***ADOPTION OF AN AMENDMENT TO  
THE PUBLIC FACILITIES MANUAL  
OF THE COUNTY OF FAIRFAX, VIRGINIA***

*That the Public Facilities Manual of the County of Fairfax, Virginia, is amended, as follows:*

**Proposed Amendment to Chapter 2 (General Subdivision and Site Plan Information)  
of  
the Public Facilities Manual**

#### **6-1110 Storm Sewer Construction Specifications**

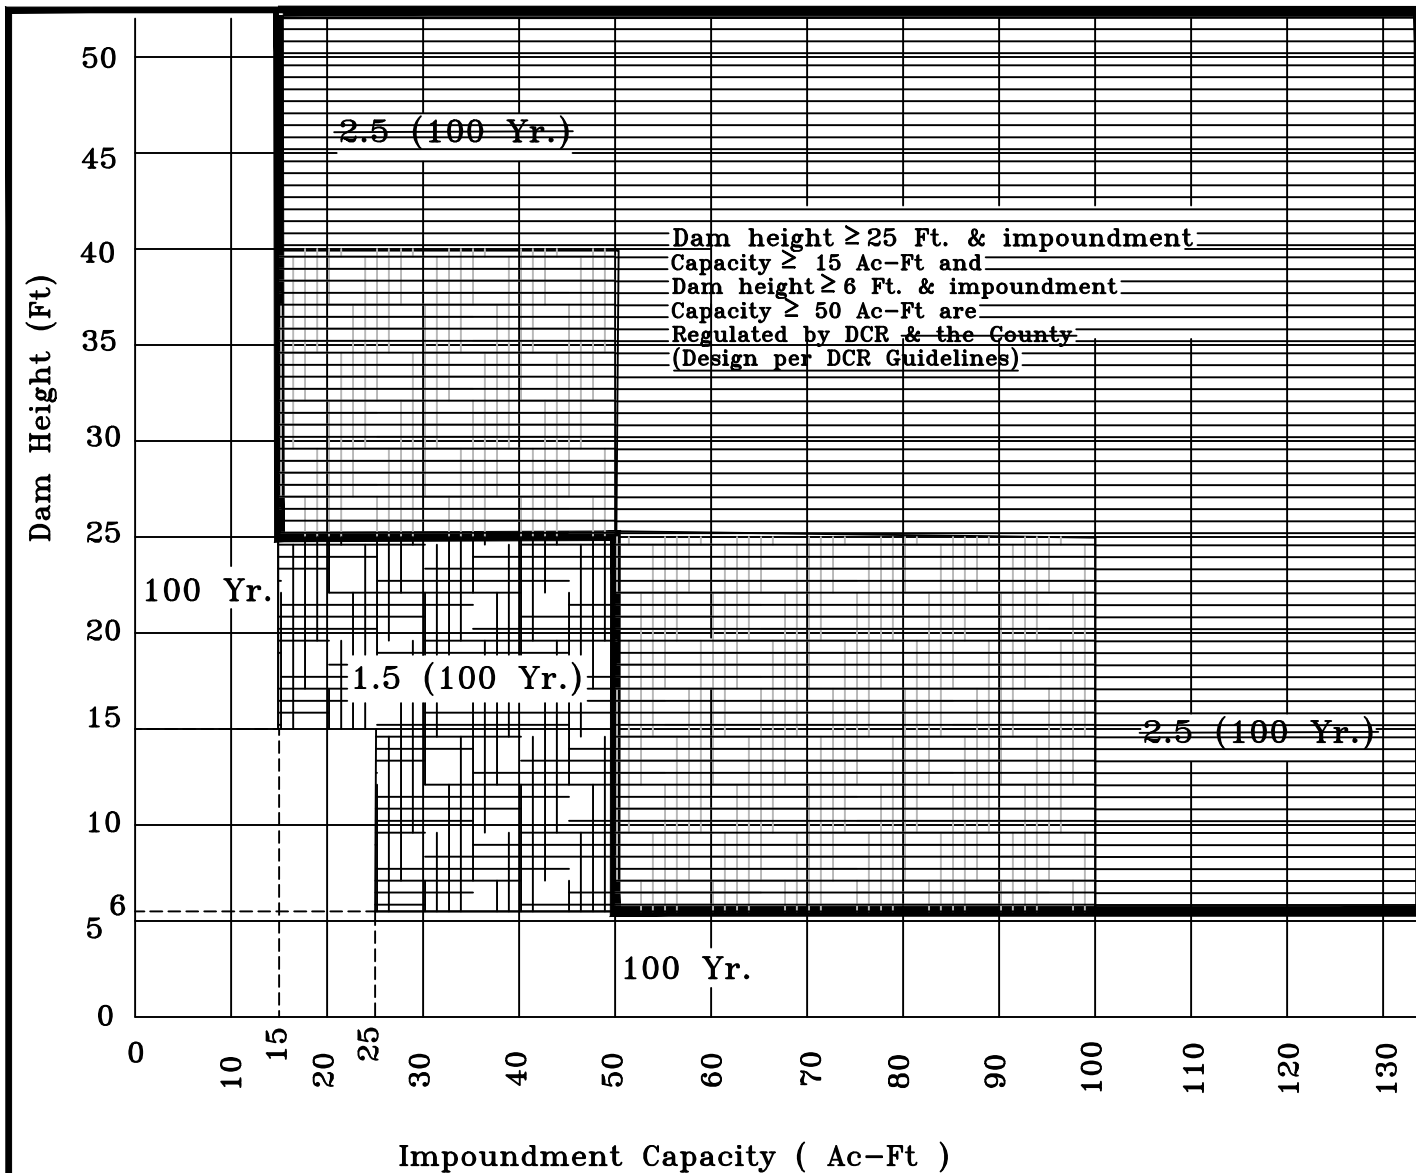
**Amend Section 6-1110 (Storm Sewer Construction Specifications), by revising Subsections 6-1110.3 and 6-1110.13 to read as follows:**

6-1110.3 Drop inlets, manhole structures and curb inlets must have steps. The maximum dimension from finished grade to the first step in the inlet may not exceed 3 feet 3 inches. Steps must be aligned with structure access openings. In cases where the structure top is wider than the structure, openings must be aligned to allow access to the steps in the structure base.

6-1110.13 A handrail, guardrail, fence or other protective device is required when the height of an endwall is 2 feet or greater and the structure is located near residence or pedestrian walkways. The protective device must be shown on the plan. Guardrails ~~will~~ must be so placed so as to perform their intended function, ~~for which it is intended~~ and the height of the guardrail must extend 36 inches above the ~~surrounding area~~ high side of the endwall.

Ref. Sec. 8-0202.1B, 8-0203.1B  Rev. 1-00, 2011 Reprint, 2018 Reprint, <del>xx</del> -20	<b>TRAIL CROSS-SECTIONS</b>		PLATE NO.	STD. NO.
			2-8

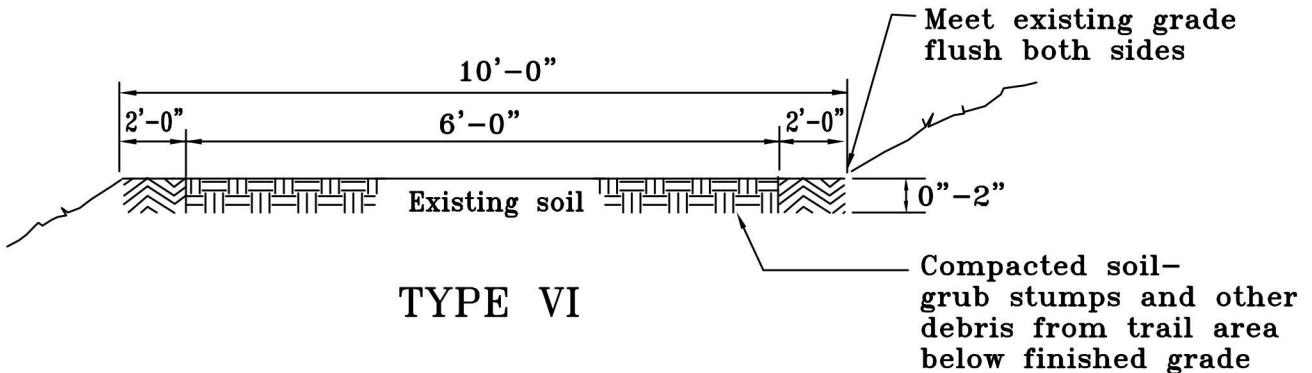
Suitable for general use. ~~Un~~Suitable for bikeways if the width is greater than or equal to 8 FT. Acceptable for VDOT maintenance.

## Critical Root Zone Formula

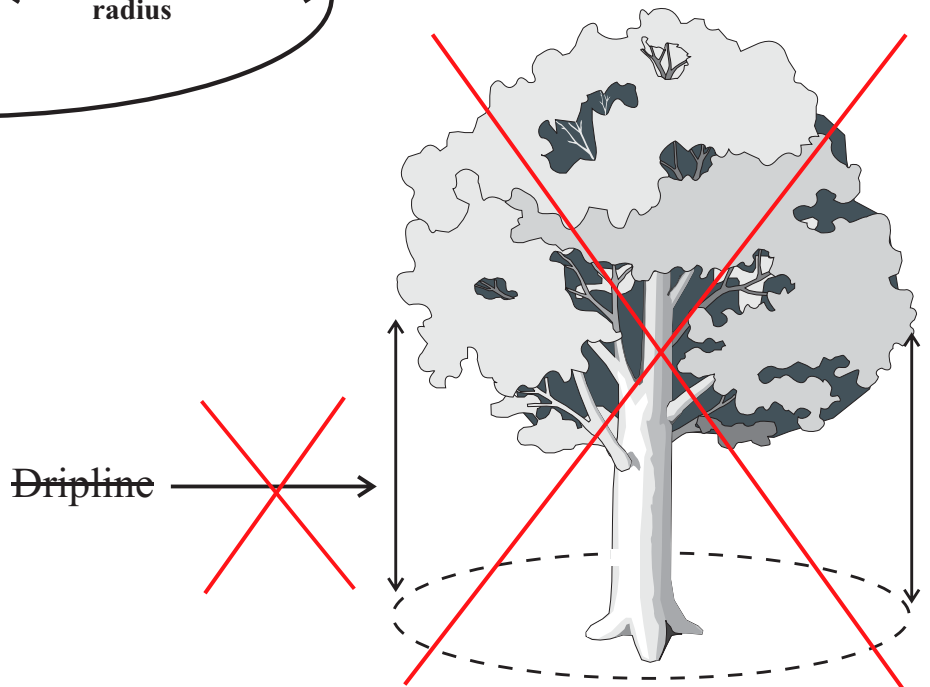
**Amend Chapter 12 Plates by revising Plate 2-12 (Critical Root Zones of Trees), Plate 3-12 (Tunneling Guidelines), Plate 5-12 (Deck Planter), Plate 6-12 (Tree Protection Fence Installation), Plate 7-12 (Tree Protection Fence Installation & Root Pruning), and Plate 8-12 (Planting Tree Seedlings) as follows:**

Critical Root Zone (CRZ)  
of ~~Forest-Grown Tree~~

6-12

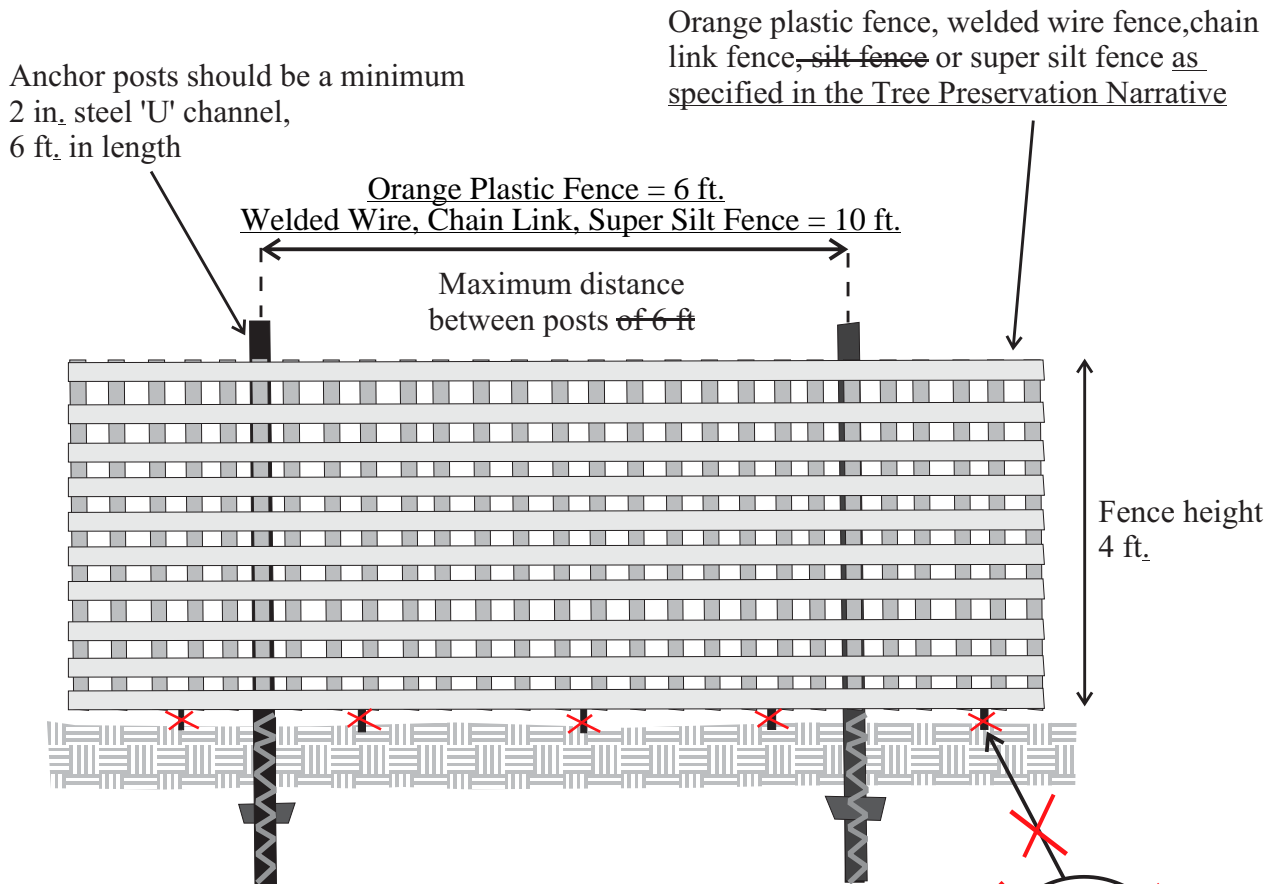
**Note: Tree protection fencing ~~should~~ must be maintained throughout construction until removal approved by County**
